Form 3160-5 (August 2007)

1. Type of Well ☑ Oil Well ☐ Gas Wei	il П Other						8. Well Name and No. PLU PIERCE CANYON 4-25-30 1H				
Name of Operator	ii 🛅 Other		NAOMI G O'			9. API Well No.					
BOPCO, L.P.		E-Mail: ngodonnell	· · · · · · · · · · · · · · · · · · ·			30-015-4//37					
3a. Address 3b. Phone No. (include area code) P.O. BOX 2760 Ph: 432-683-2277 MIDLAND, TX 79702 Ph: 432-683-2277						10. Field and Pool, or Exploratory NASH DRAW; DELAWARE

BOPCO, L.P.
PLU Pierce Canyon 4-25-30 1H
T25S-R30E, Sec 04
June 7, 2013

Internal Hydrostatic Test Graph

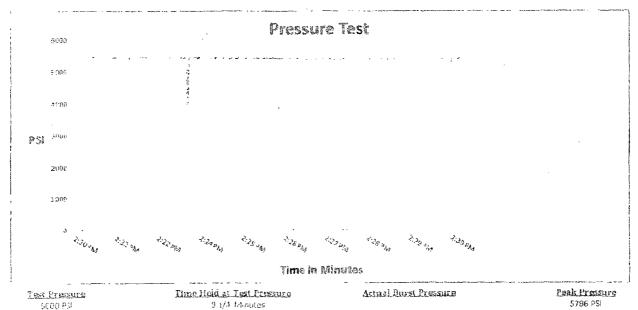
1. Variance approved to use flex line from BOP to choke manifold. Check condition of flexible line from BOP to choke manifold, replace if exterior is damaged or if line fails test. Line to be as straight as possible with no hard bends and is to be anchored according to Manufacturer's requirements. The flexible hose can be exchanged with a hose of equal size and equal or greater pressure rating. Anchor requirements, specification sheet and hydrostatic pressure test certification matching the hose in service, to be onsite for review. These documents shall be posted in the company man's trailer and on the rig floor. If the BLM inspector questions the straightness of the hose, a BLM engineer will be contacted and will review in the field or via picture supplied by inspector to determine if changes are required (operator shall expect delays if this occurs).
